## **INFORMATIONAL MEMORANDUM**

**SUBJECT: Zoning Code amendments to TMC 18.41 and new design guidelines for multifamily development in the Tukwila South Overlay (TSO) district.**

**STAFF REPORT TO THE PLANNING COMMISSION**

- FILE NUMBER:** L19-0115 Comprehensive Plan/Zoning Code Amendment
- ASSOCIATED FILES:** E19-0011 SEPA Checklist
- REQUEST:** Zoning Code amendments to TMC 18.41 and new design guidelines for multifamily development in the Tukwila South Overlay (TSO) district.
- Planning Commission (PC) will hold a future public hearing on the proposed amendments and make recommendations to the City Council for review and adoption.
- PUBLIC HEARING:** The June 10, 2021, meeting is a continuation of the public hearing that commenced on March 18, 2021.
- LOCATION:** Lands within the Tukwila South Overlay district.
- STAFF:** Max Baker, Senior Planner
- ATTACHMENTS:**
- A. 4.22.2021 PC Meeting Staff Report – Applicant Comments Provided 4.22.2021 + Staff Responses
  - B. Draft Design Guidelines – Provided at 4.22.2021 PC Meeting

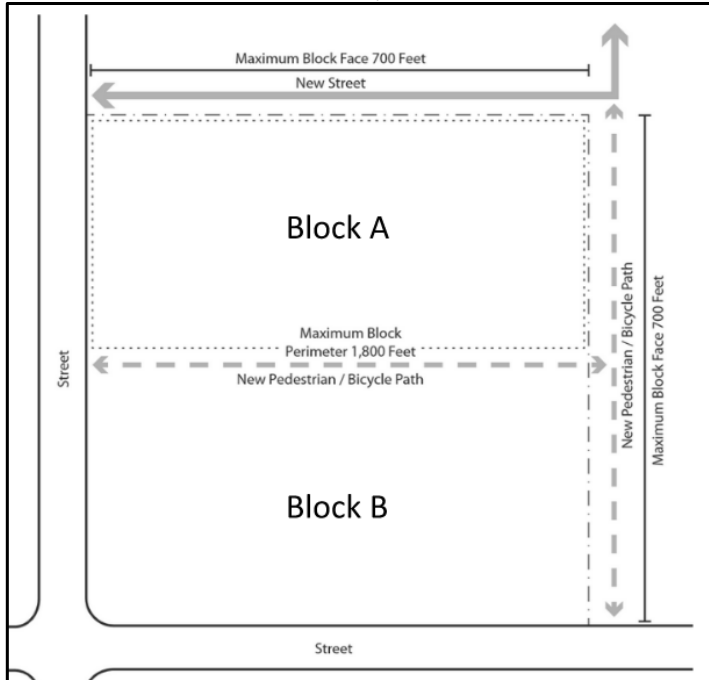
**Commented [MP17]:** Segale suggest this redlined language may be easier to measure as the perimeter is easy to find as opposed to 50% of the proposed units.

**Commented [MP19]:** Unless I am mistaken the connectivity and circulation language is a guideline and not a standard. Given that, should the opening sentence read “in addition to the development standards revisions discussed above, staff recommends additional guidelines to aid in ensuring residential connectivity is provided through the residential component of the project.

**Commented [MB18R17]:** Staff recommends using suggested language for proximity to recreation areas: “The closest structure containing residential units (not including accessory buildings such as fitness centers, parking garages, utility structures, etc. must be located within ¼ mile...”
